**City of Lino Lakes
Environmental Board Meeting
July 27, 2016
6:30 P.M.
Pre-Board Field Meeting will be at Chavez Preserve Site
5:45 P.M.**

**ENVIRONMENTAL BOARD
AGENDA ITEM 5A**

REQUEST: Preliminary Plat and Site Plan Review
Chavez Preserve

PRELIMINARY PLAT, RESOURCE INVENTORY and CERTIFICATE OF SURVEY

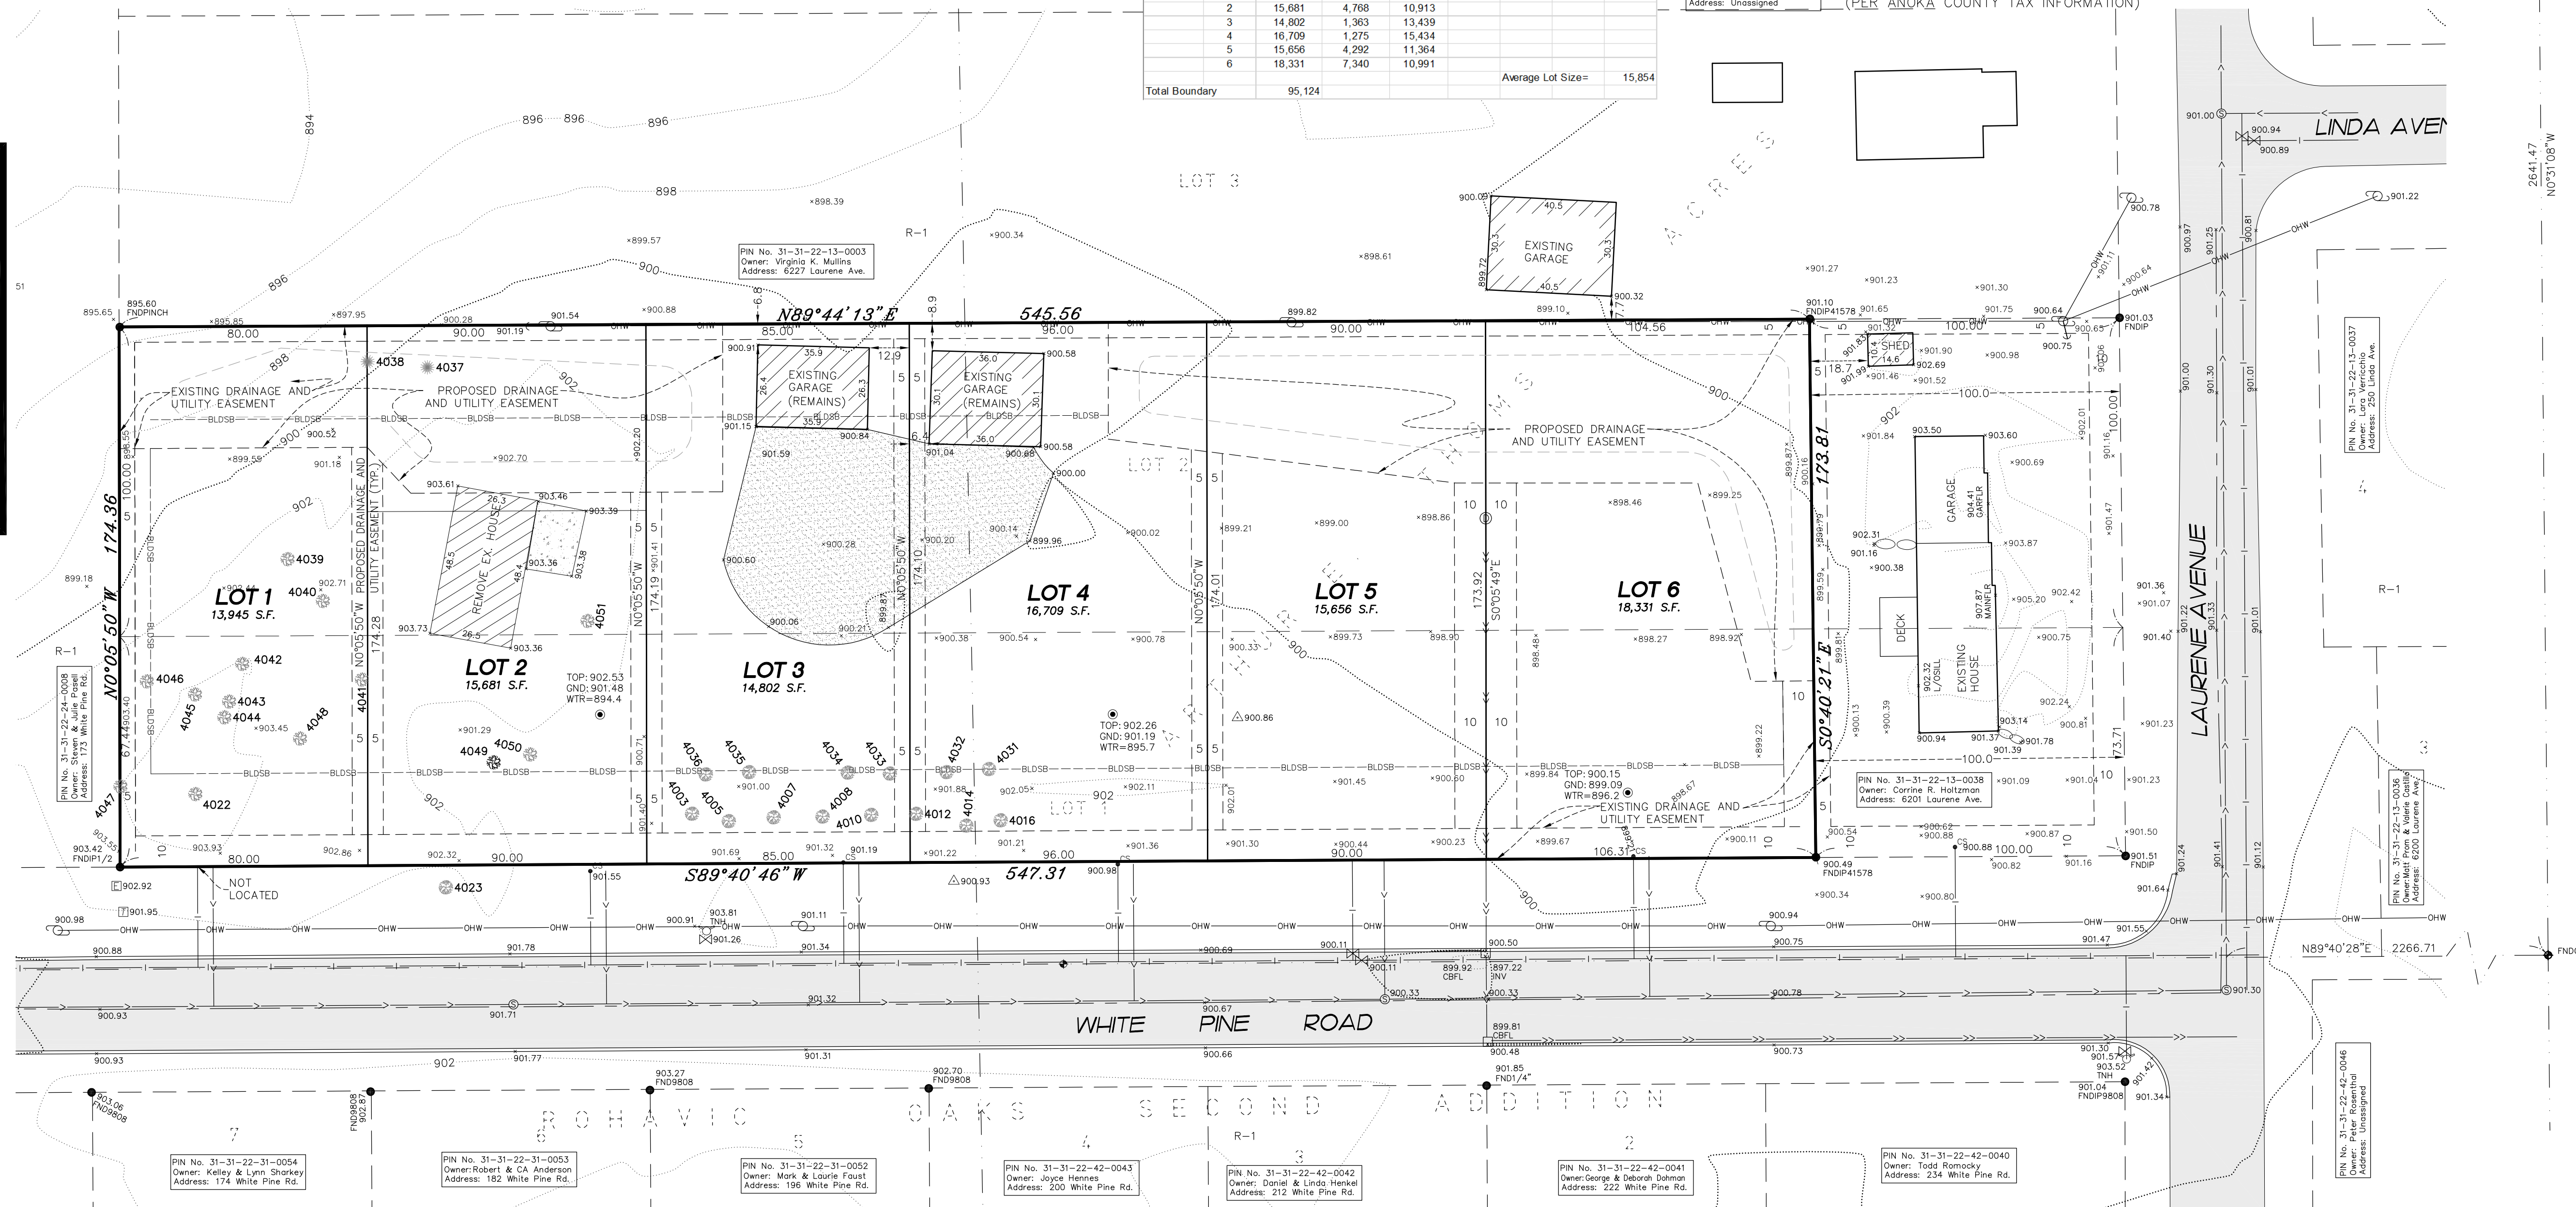
Soil boring information was not provided at the application time. Soil boring information must be made available to the city for review.

The following list of trees are proposed for removal. The trees are all in the basic use area and are allowed to be removed without replacement.

There may be a small sliver of wetlands on the NW side of the parcel. Given the area of concern is in a wetland preservation corridor, it is possible that RCWD may require appropriate replacement and buffer, unless the area meets a de minimus threshold. The developer needs to submit a wetland delineation for the site. If there is wetland in a wetland preservation corridor on the site then a 50 foot buffer will be needed. Pond 1 is shown in the hypothetical buffer area. This is allowable.

GRADING, DRAINAGE & ESC PLAN

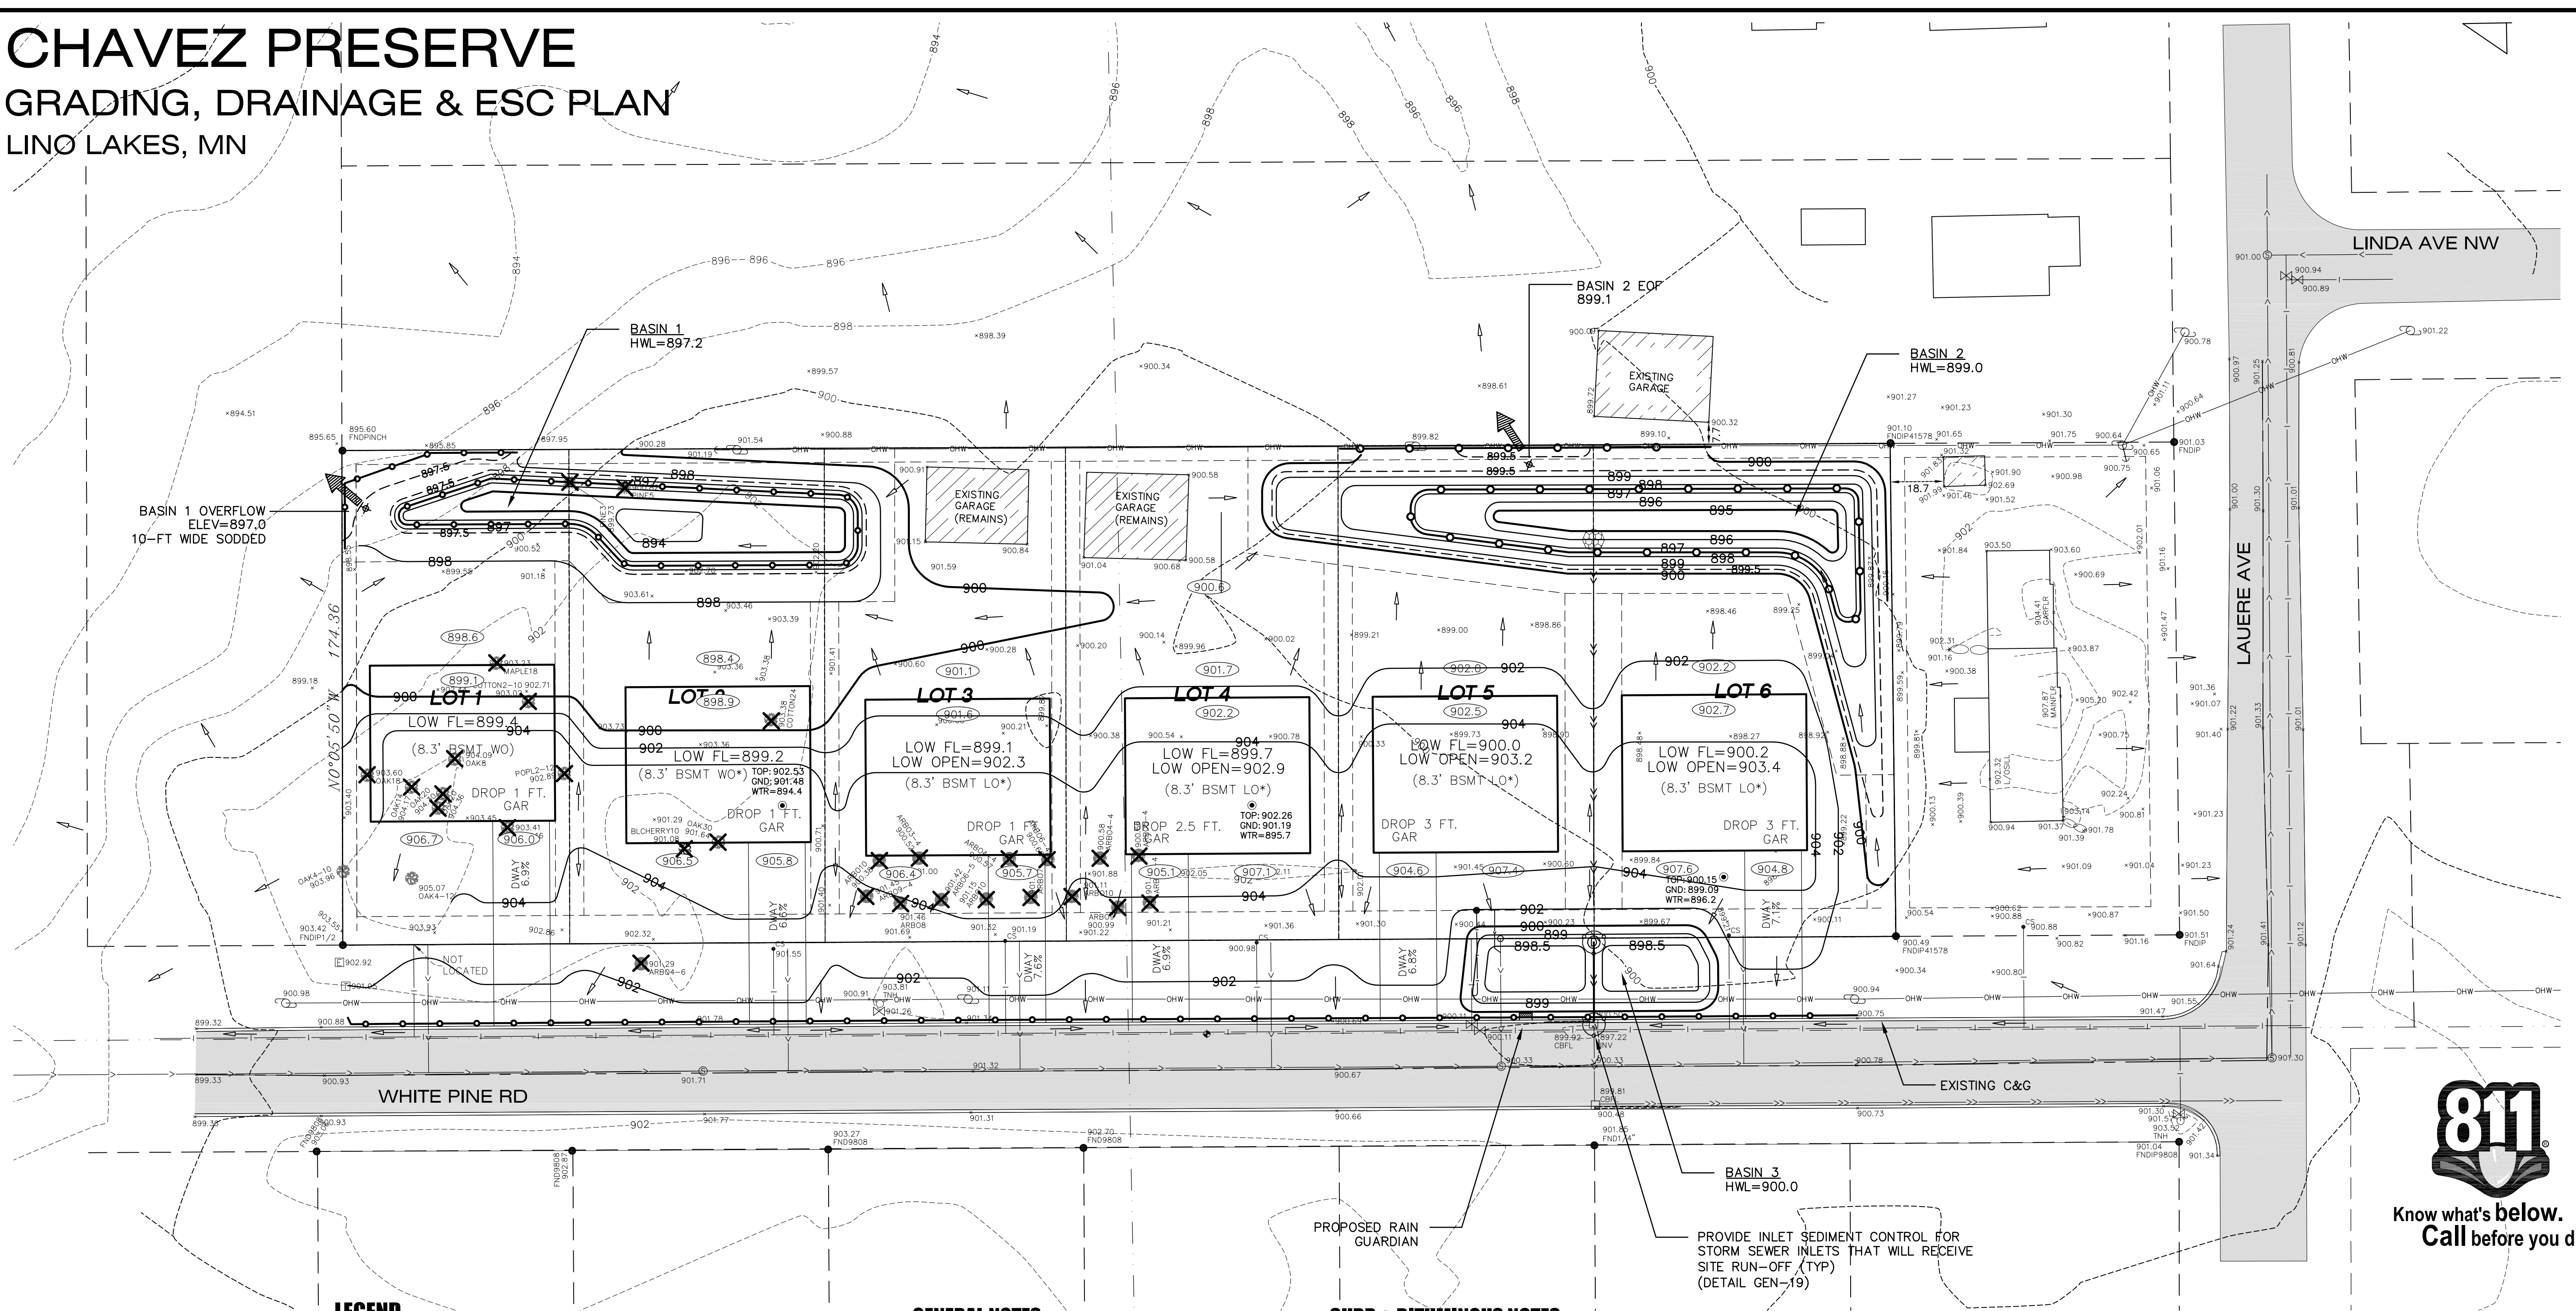
There are two ponds proposed for the north side of the property, and a rain garden proposed for the south side of the property. None of the ponds are suitable for infiltration in that the water tables are too high. The developer is proposing NURP and drainage to the NW in the NW corner pond and to the North in the East side pond. Drainage must not exceed existing rates of discharge from the site or allowable volumes. Proof that water leaving the site on the north side will not create wetter conditions for residents down stream.

The south side has a rain garden designed into it. This rain garden is for rate control only. Staff is proposing they move this rain garden between the two ponds on the north.

The eastern half of the site falls into the “moderately-suseptable to groundwater contamination” designation. Precautions should be taken to contain fuels, and dispose of concrete wash out for the entire site. Water tables are high enough in this area to make infiltration infeasible. Standards call for at least a 3 foot separation from the bottom of infiltration ponds to the water table. The developer is calling the ponds on the north side

NURP. Since these ponds will be designed into the water table, a clay liner should be applied to prevent surface water contamination to the ground water.

LANDSCAPE PLAN

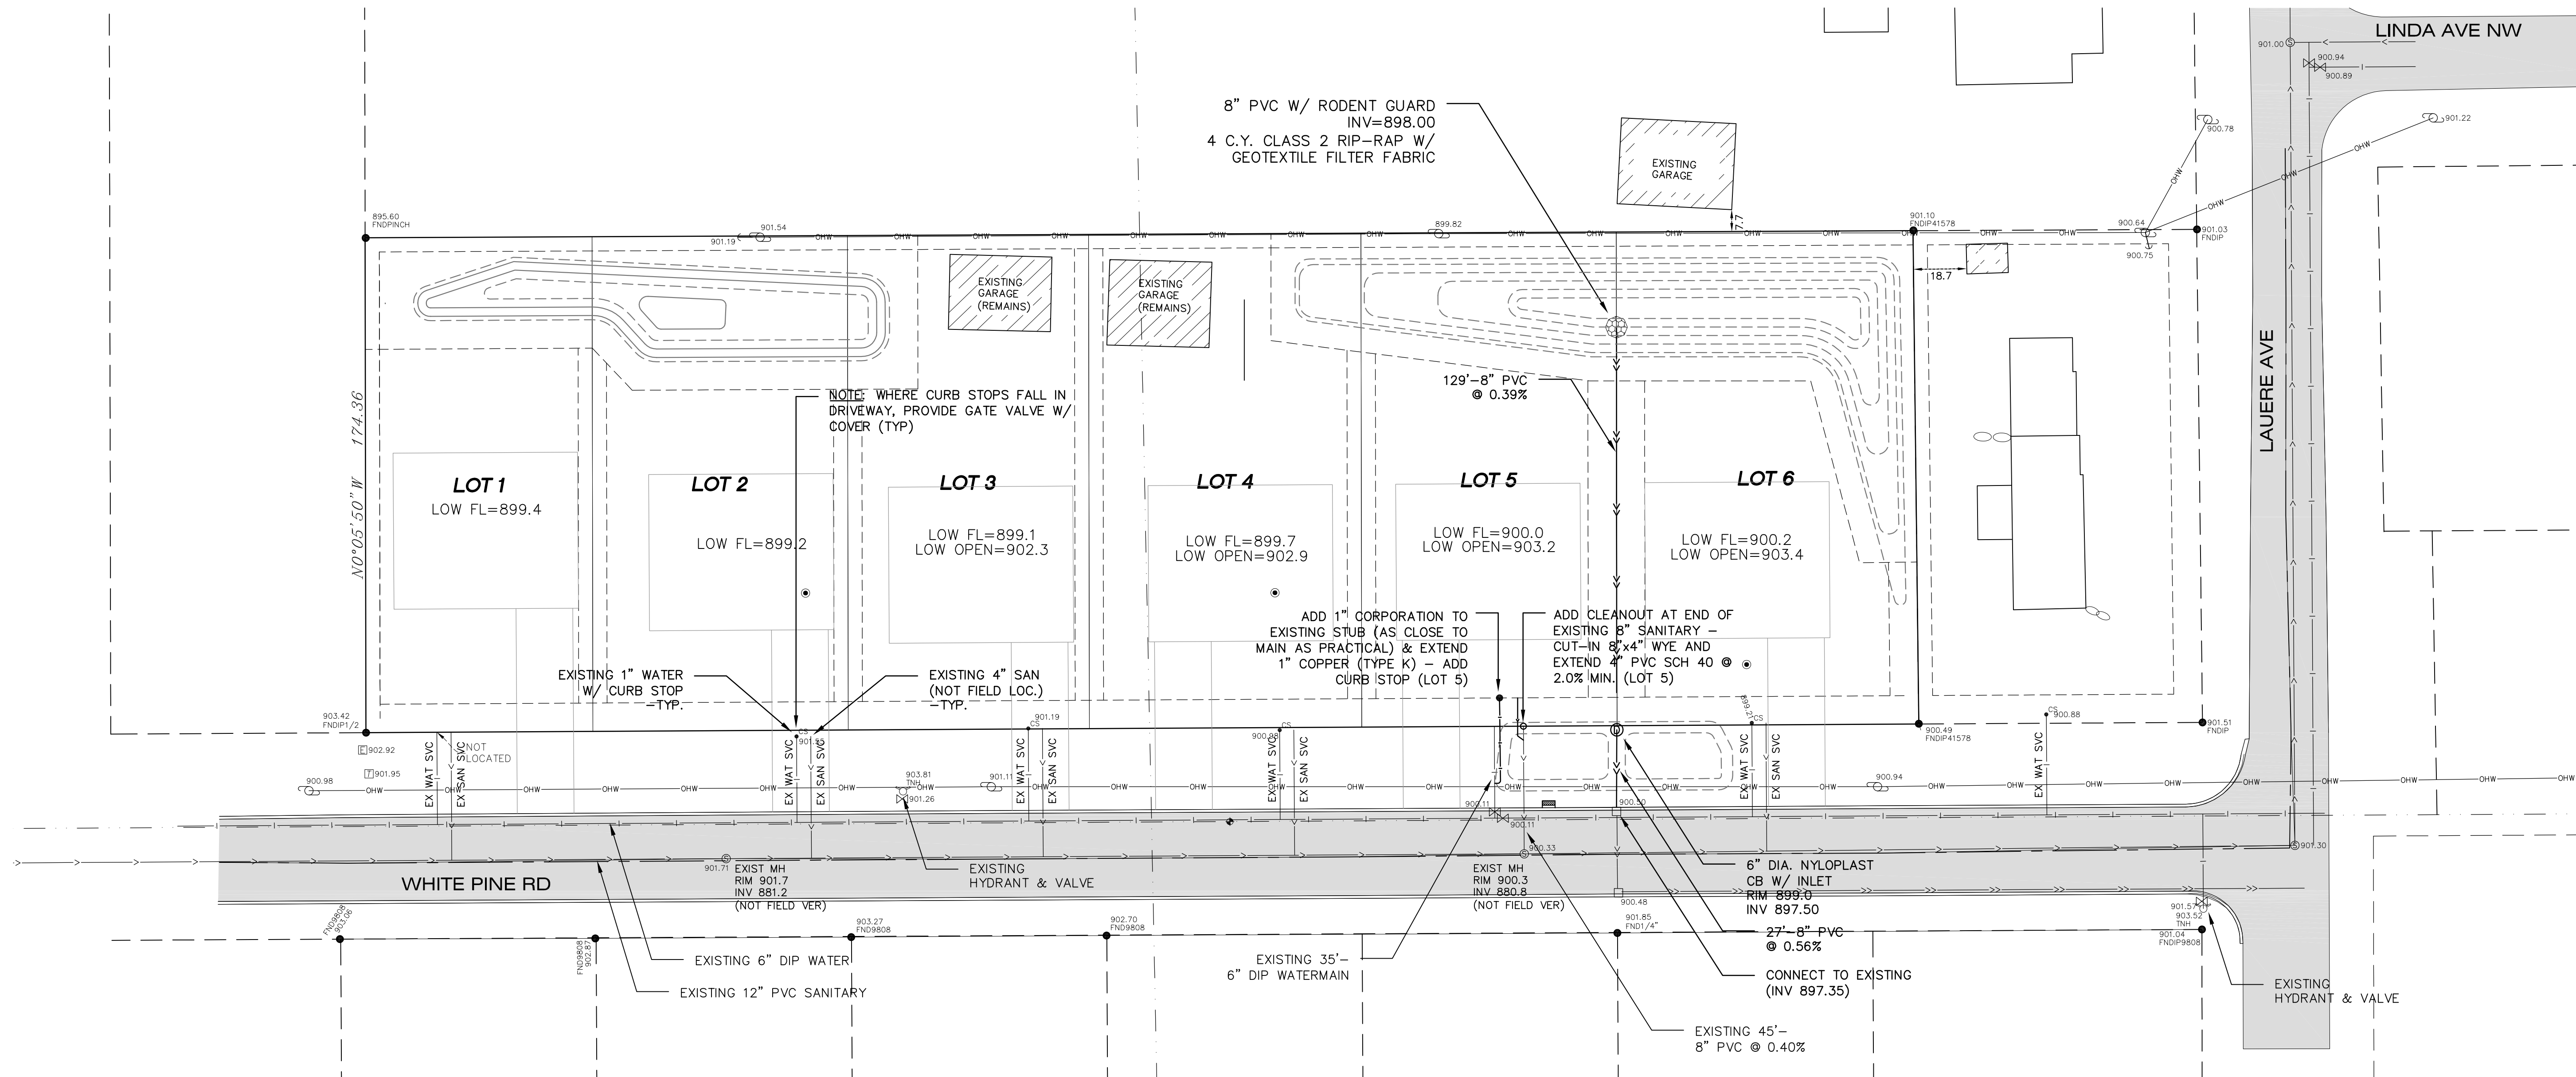
As with all past projects the City has required the escrow of enough money to plant one boulevard tree per lot frontage.

Seed mix 33-641 is a seed mix that is specified as a native plant for stormwater facilities, in SE Minnesota that will have a mesic condition. The exact seed content must be approved by the City. Forb enhancement has been required in past projects. A higher level of forb seed as a percentage of the seed mix will be required.

The seed must be applied by a contractor approved by the city that is knowledgeable in the cultural practices of native plants. A three year maintenance plan must be submitted for the native seed area. The plan must be approved by the City. A contractor that is knowledgeable in the cultural practices for native seeded areas must be used and approved by the city.

Trees planted in the native seed areas must be fire tolerant. Burr Oak, and Swamp White Oak should be used.
